Wisconsin Electric POWER COMPANY
231 N. MICHIGAN, P.O. BOX 2746, MILWAUKEE, WI 53201

September 16, 1981

DOCKET NOS. 50-266 AND 50-301
ADDITIONAL INFORMATION
AUXILIARY FEEDWATER SYSTEM
POINT BEACH NUCLEAR PLANT, UNITS 1 AND 2

125 V D.C. ONE LINE DIAGRAM
FIGURE 2.2-10

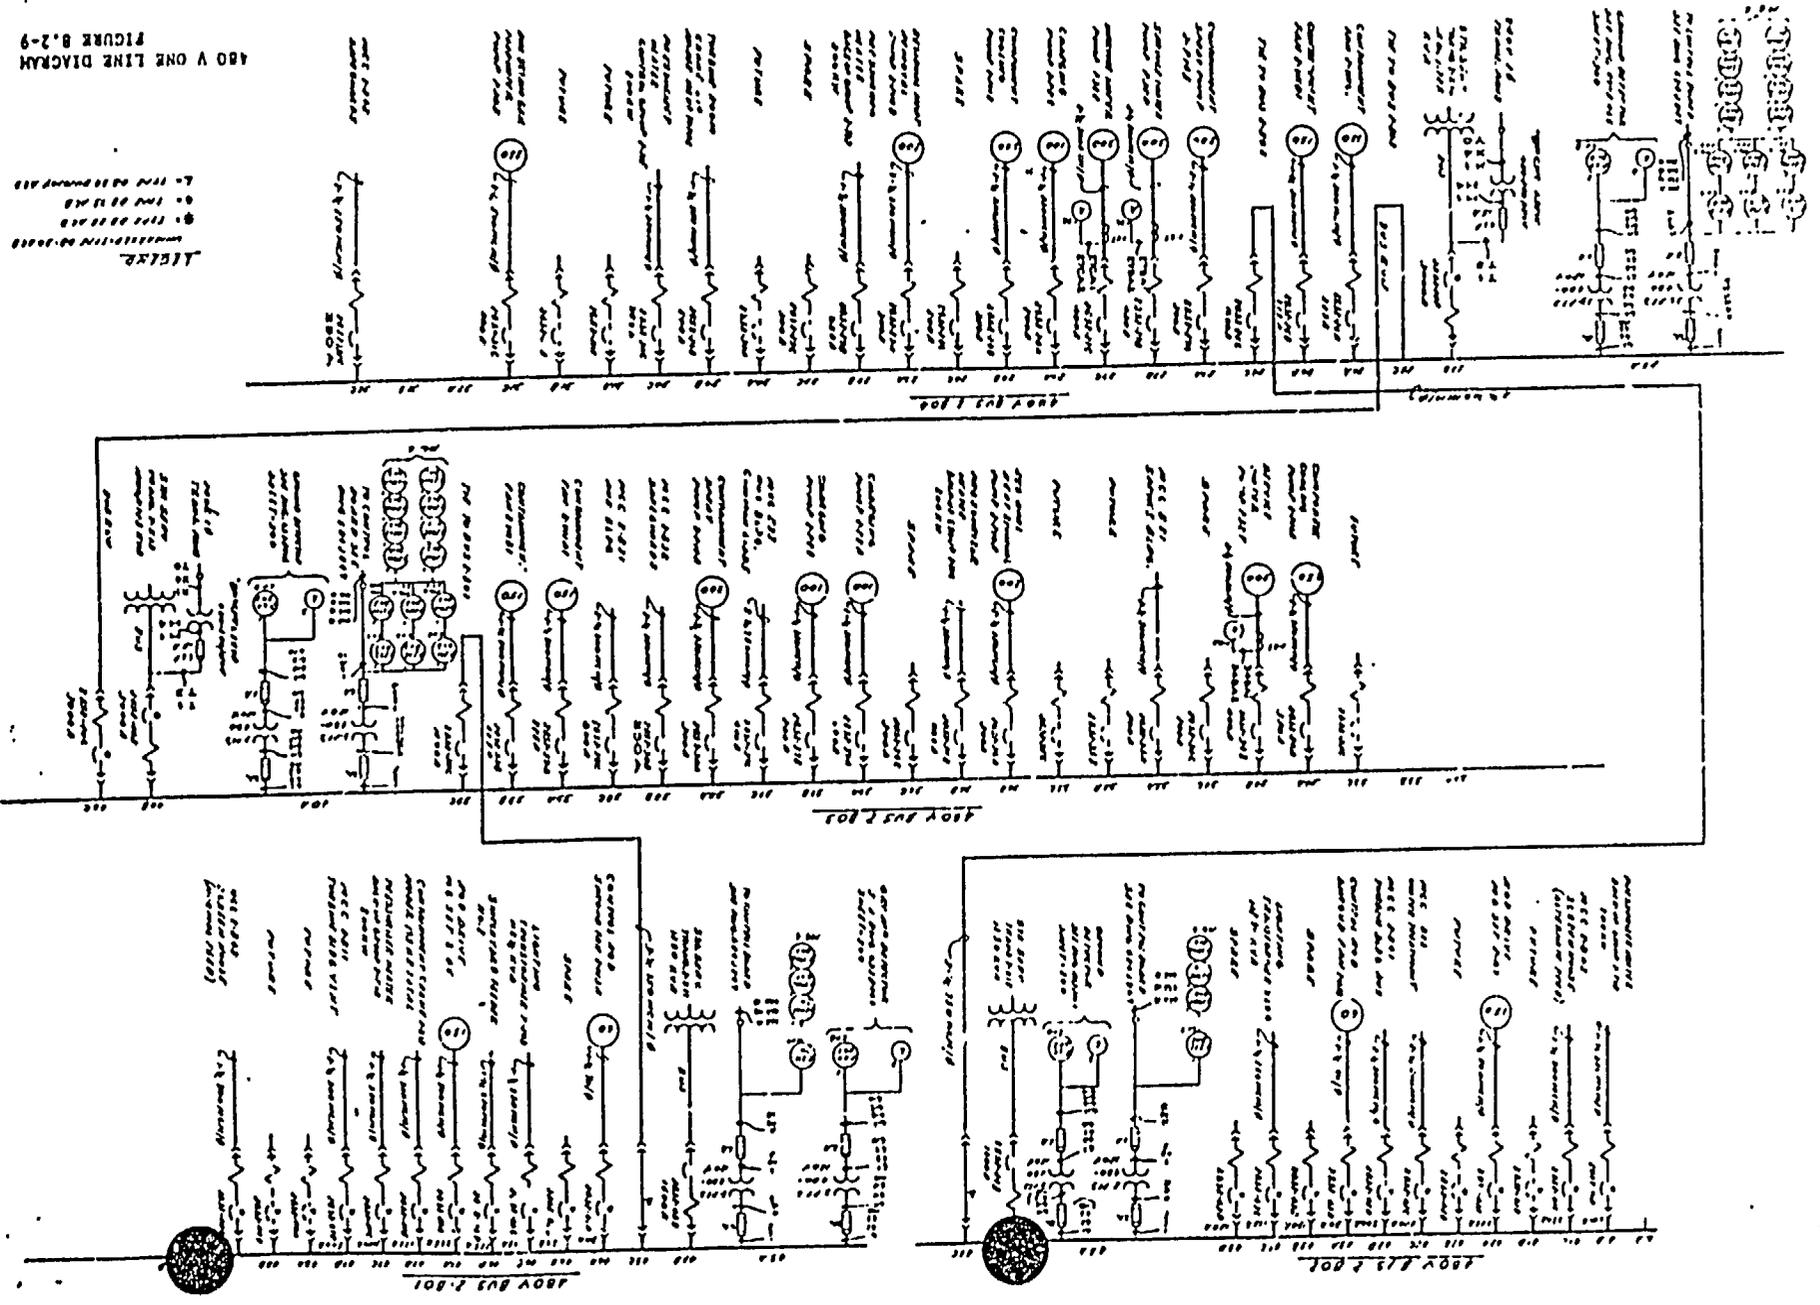
5. Provide electrical one-line diagrams for 4160V AC, 480V AC, 120V AC and 125V DC.

RESPONSE: Electrical one-line diagrams are provided in Chapter Eight of the PFDGAR. For your convenience, we have reproduced these figures and enclosed them with
